AGENDA
DESIGN COMMISSION
Community Room, 3rd Floor
Arlington Heights Village Hall, 33 S. Arlington Heights Rd.
Arlington Heights, IL 60005
June 24, 2025
6:30 PM

Item: 623 N. Beverly Ln. - Rooftop Mechanical Units / Single-Family
- DC#25-043

Project Name: Brophy Residence
Project Address: 623 N. Beverly Lane
Prepared By: Steve Hautzinger

Brophy Residence
623 N. Beverly Lane
Arlington Heights, Illinois
Exterior Elevations

FRONT ELEVATION (West)

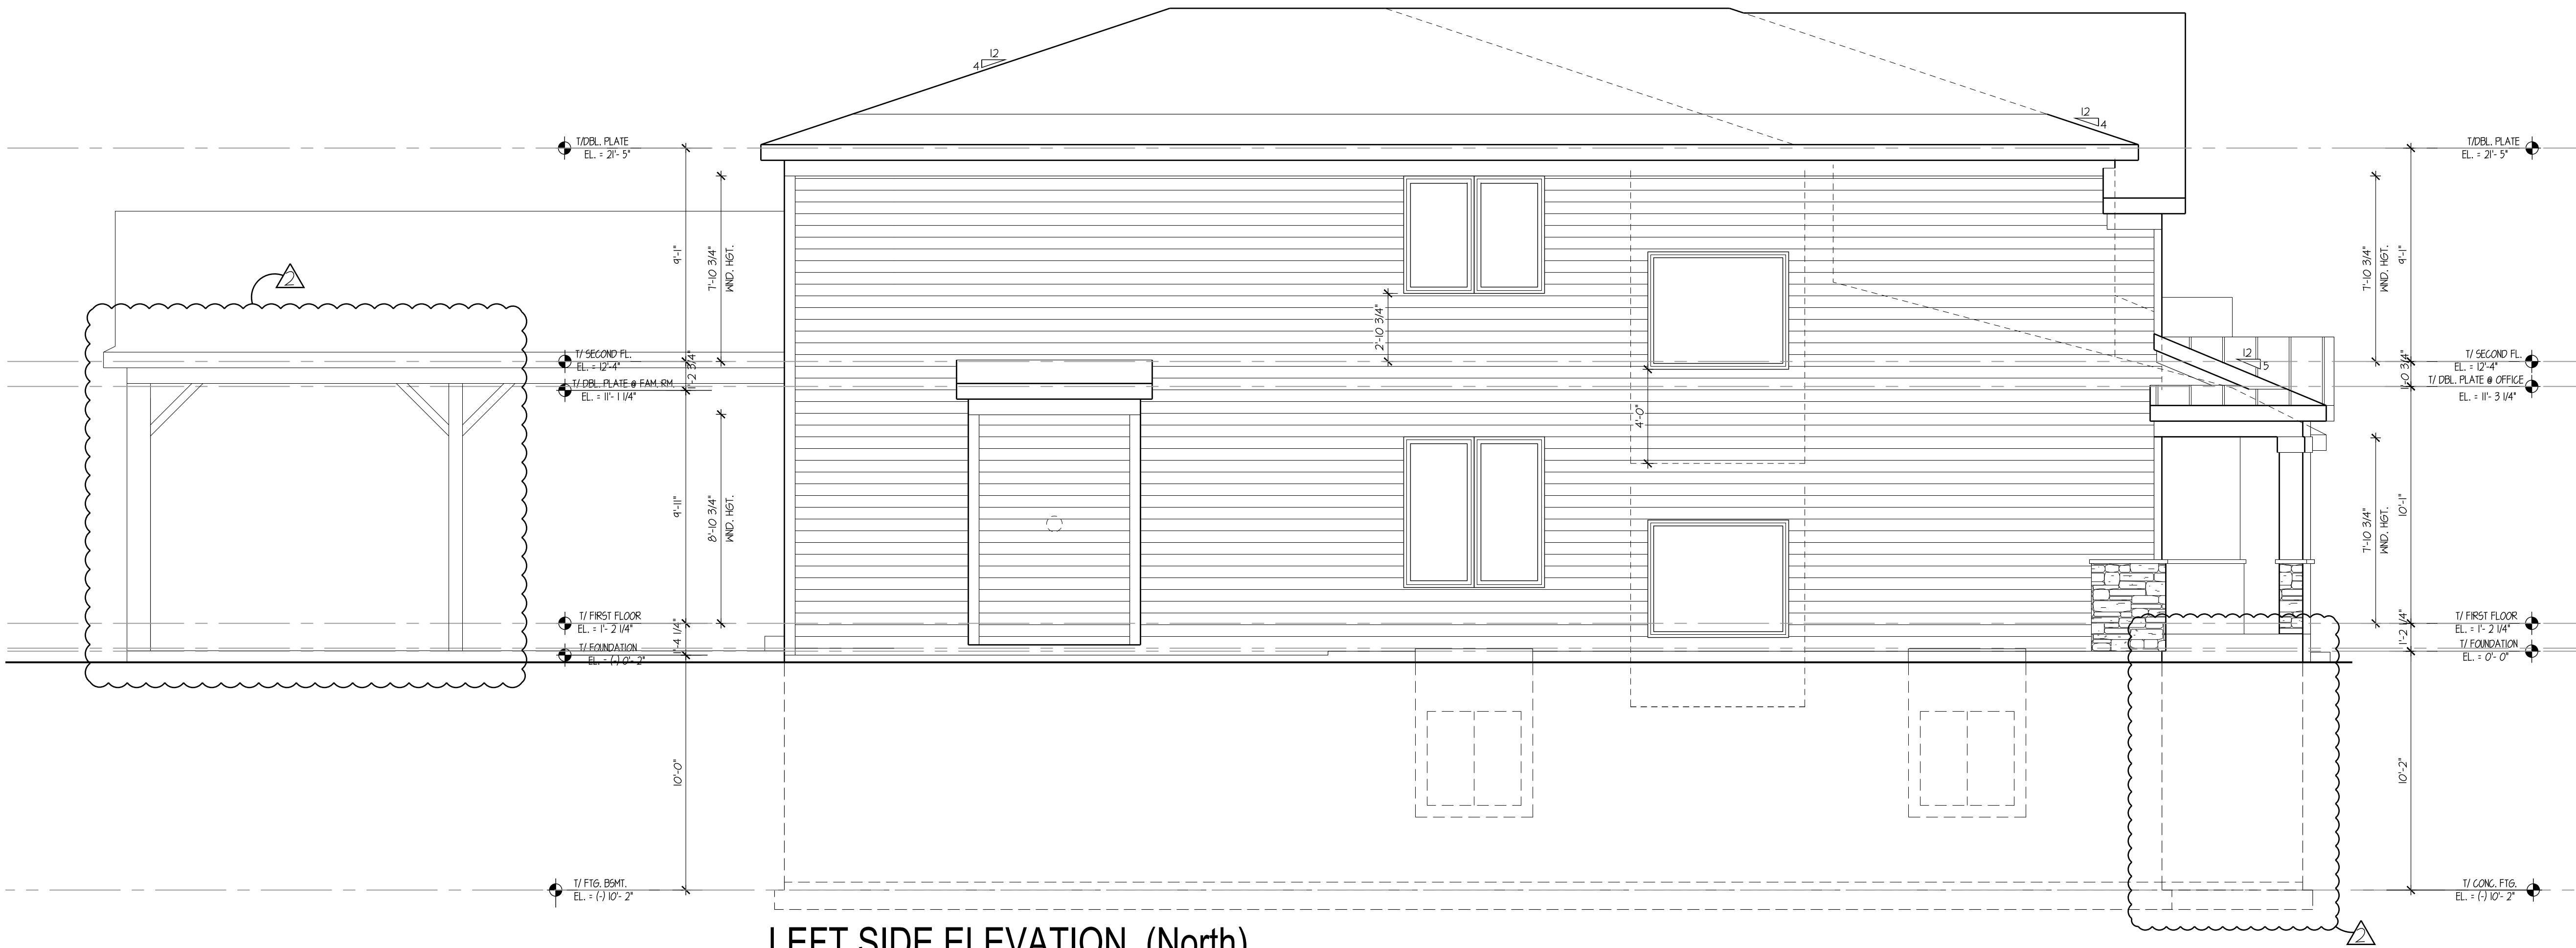
Placement of the mechanical equipment on the porch roof is unusual, and it raises concerns regarding possible visual and acoustical nuisance to the adjacent property. Mechanical units located on grade can also possibly cause visual and acoustical nuisance to neighbors, but when mechanical equipment is on grade, neighbors have the option to install fencing and/or landscaping to buffer the impact. In this case, the neighbors have no option to screen the units, and since the units are already installed, it puts the neighbors in a difficult position to raise objection.

1. Staff suggests the following options for the Design Commission's consideration:
 - a. Approve as submitted with lattice screen wall.
 - b. Require a solid screen wall instead of the proposed decorative lattice to fully screen the units as well as to help deflect the sound away from the adjacent property.

- c. Flip the location of the rooftop units to the north side of the porch roof (with screening) which would be less impactful to the adjacent properties.

- d. Require the units to be relocated to grade as originally approved.
2. This review deals with architectural design only and should not be construed to be an approval of, or to have any other impact on, any other zoning and/or land use issues or decisions that stem from zoning, building, signage or any other reviews. In addition to the normal technical review, permit drawings will be reviewed for consistency with the Design Commission and any other Commission or Board approval conditions. It is the architect/homeowner/builder's responsibility to comply with the Design Commission approval and ensure that building permit plans comply with all zoning code, building permit and signage requirements.

ROOF PLAN
SCALE: 1/8" = 1'-0"

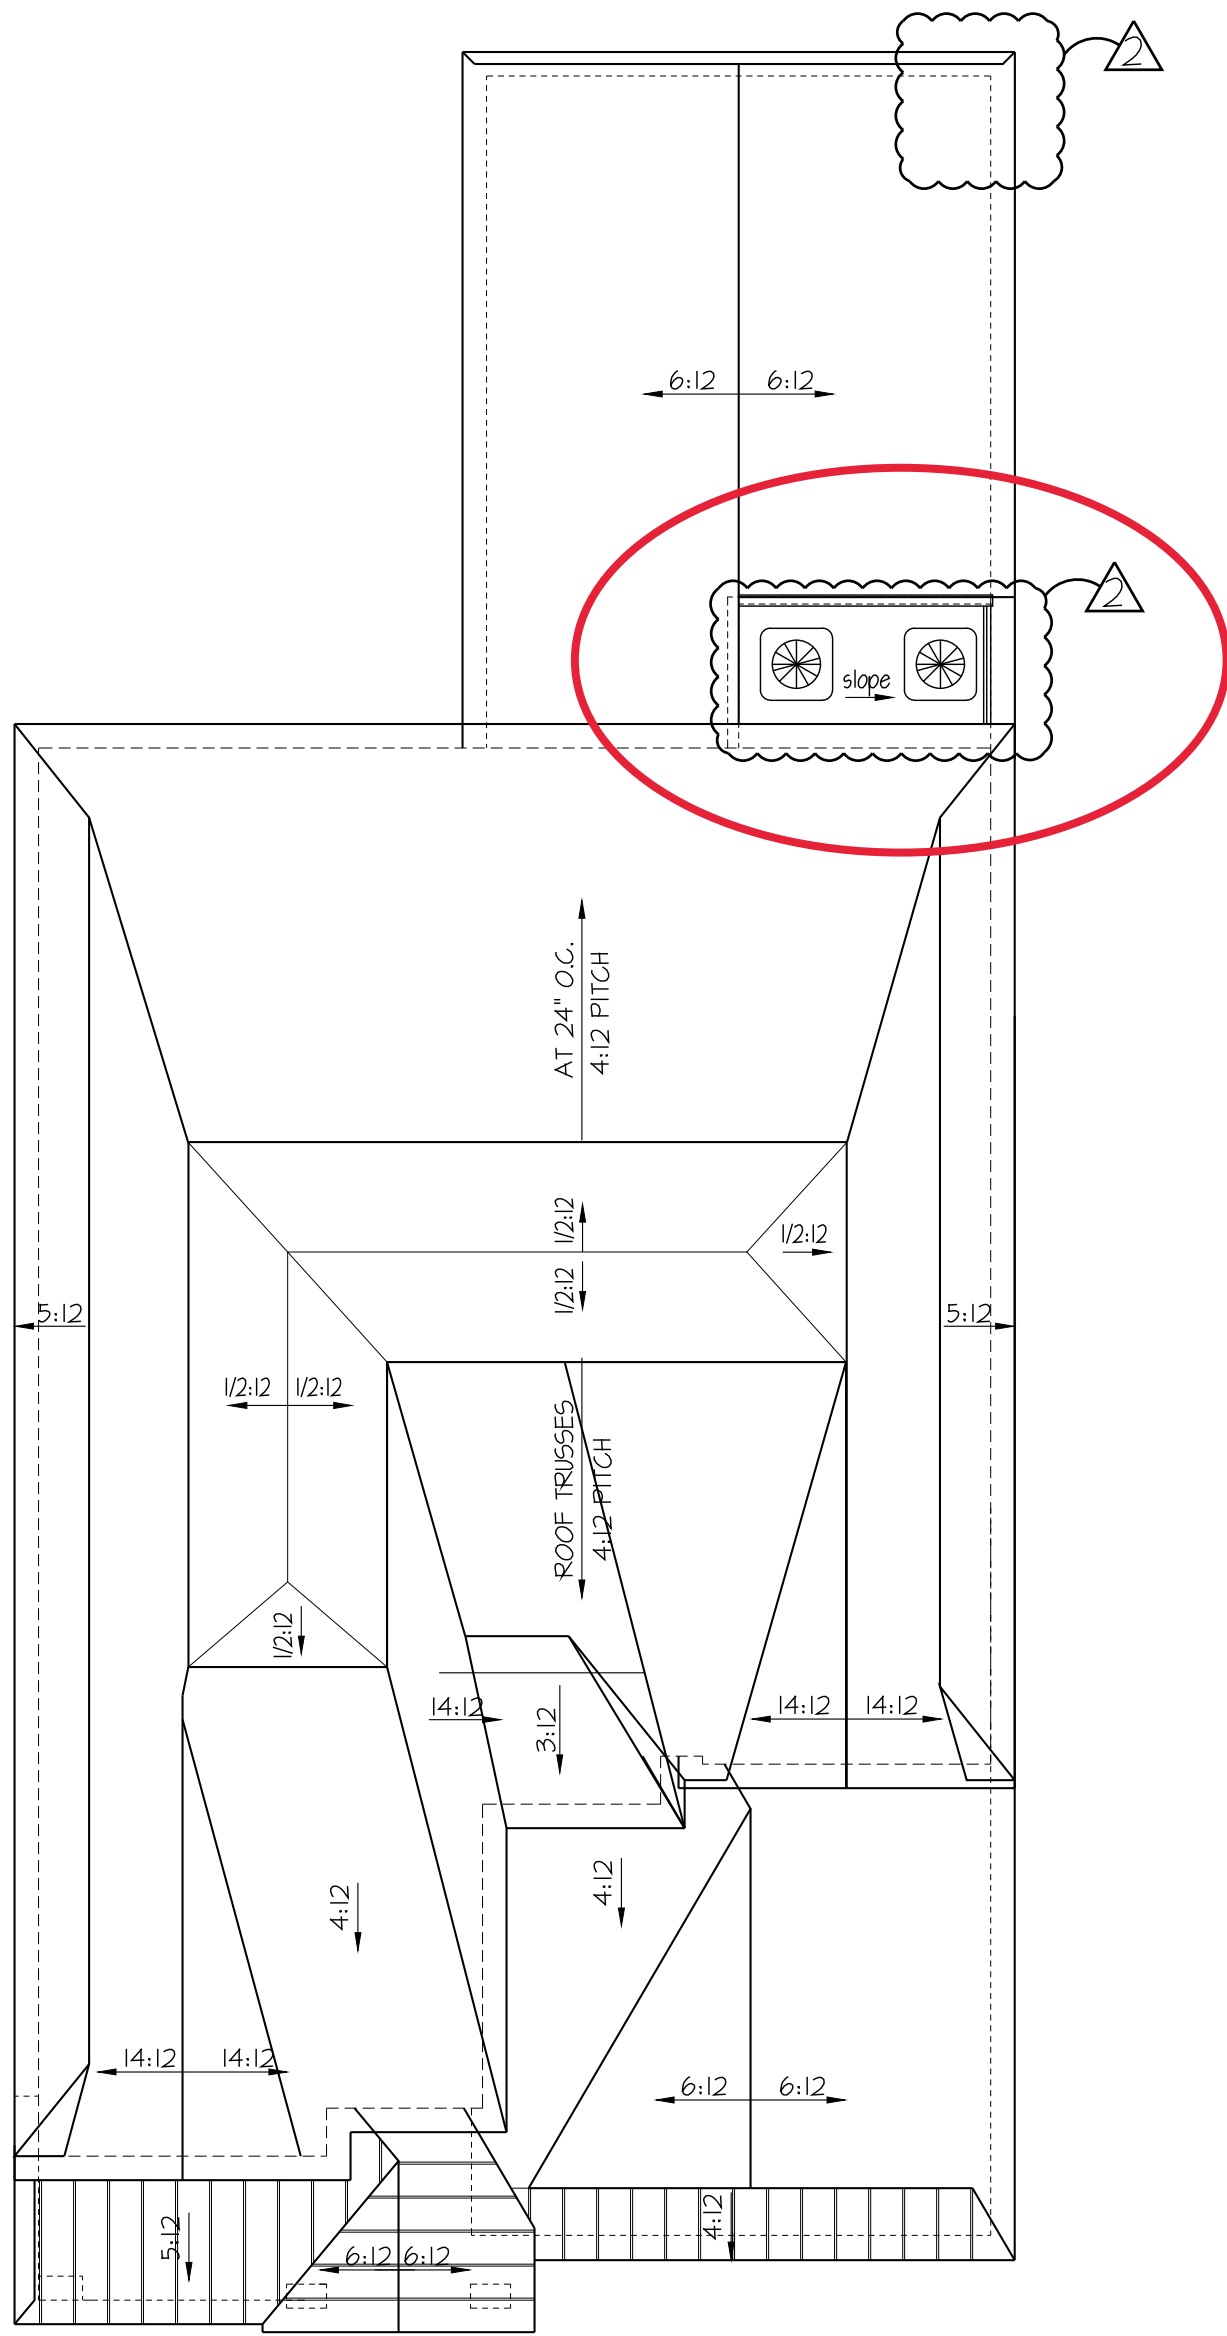
At this time, construction of the home is nearing completion, and the petitioner is in the process of obtaining permit approvals for various as-built changes that were made in the field without permits. One of the as-built changes is the relocation of grade-mounted mechanical equipment to a rooftop location on the back of the house. The design of the house includes a covered patio structure with a gable roof that was modified to incorporate a flat area for the mechanical equipment. A solid knee screen wall facing the rear of the property was constructed, but the side of the mechanical well is currently fully open.

The Village's Design Guidelines require roof mounted mechanical equipment to be completely screened with sound absorbent materials harmonious with the building. The petitioner is proposing a decorative lattice screen to enclose the side of the equipment well.

1. Approve as submitted with the proposed lattice screen wall.
2. Require a solid screen wall instead of the proposed decorative lattice to fully screen the view of the units as well as to help deflect the sound away from the adjacent property.
3. Flip the location of the rooftop units to the north side of the porch roof (with screening) which would be less impactful to the adjacent properties.
4. Require the units to be relocated to grade as originally approved.
